Access Compliance Report

Public Rights-of-Way

Intersection ID: 31234	Main Street: AVONLEA_CT	Cross Street: DAVID_COX_RD	Location: SE
ADA ID: 8ACFB8253861	Ramp Type: PerpDiag	Initial Pass/Fail: Fail	Overall Compliance: No
Severity Score: 1.25			
Codes/Mitigation Info/Possible Solution		Field Measurements/Component Compliance

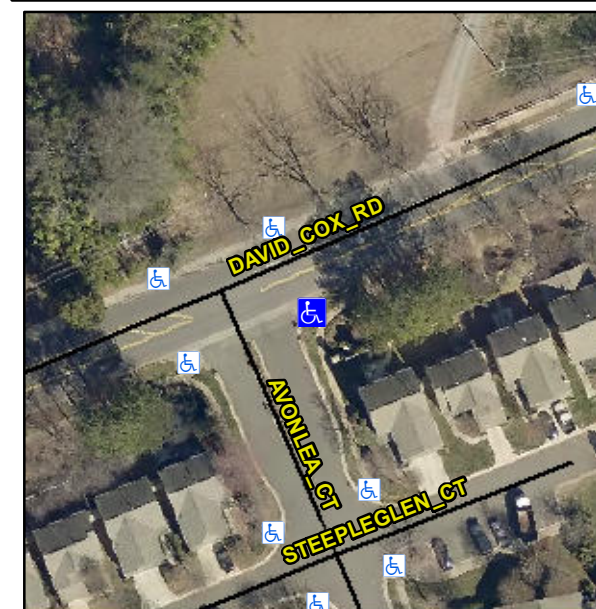
Not Found, R304.5.3

Compliance	Description	Data	Compliance	Description	Data
N/A	Ramp Length (in)	39.5	Yes	Ramp Slope (%)	6.6
Yes	Ramp Width (in)	48.0	No	Ramp XSlope (%)	2.4
N/A	Flare Type LT	N/A	N/A	Flare Type RT	N/A
N/A	Flare Slope LT (%)	N/A	N/A	Flare Slope RT (%)	N/A
N/A	Flare Traversable LT?	N/A	N/A	Flare Traversable RT?	N/A
N/A	Landing Length (in)	N/A	N/A	DWS Provided?	N/A
N/A	Landing Width (in)	N/A	N/A	DWS Contrast?	N/A
N/A	Landing Slope (%)	N/A	N/A	DWS Length (in)	N/A
N/A	Landing X Slope (%)	N/A	N/A	DWS Full Width?	N/A
N/A	Landing Curb? (Y/N)	N/A	N/A	DWS Offset (in)	N/A
N/A	Shared Landing?	N/A			
N/A	Gutter Ponding?	N/A	N/A	Gutter Slope (%)	N/A
N/A	Gutter Lip Ht (in)	N/A	N/A	Gutter X Slope (%)	N/A
N/A	Painted X Walk1?	No	N/A	Painted X Walk2?	No
	X Walk 1 Direction	To N		X Walk 2 Direction	To W
N/A	X Walk 1 Width (in)	N/A	N/A	X Walk 2 Width (in)	N/A
	X Walk 1 Slope (%)	0.7		X Walk 2 Slope (%)	1.4
	X Walk 1 X Slope (%)	0.6		X Walk 2 X Slope (%)	3.1

Remove & Replace Curb Ramp With Two New Directional Ramps or Equivalent.
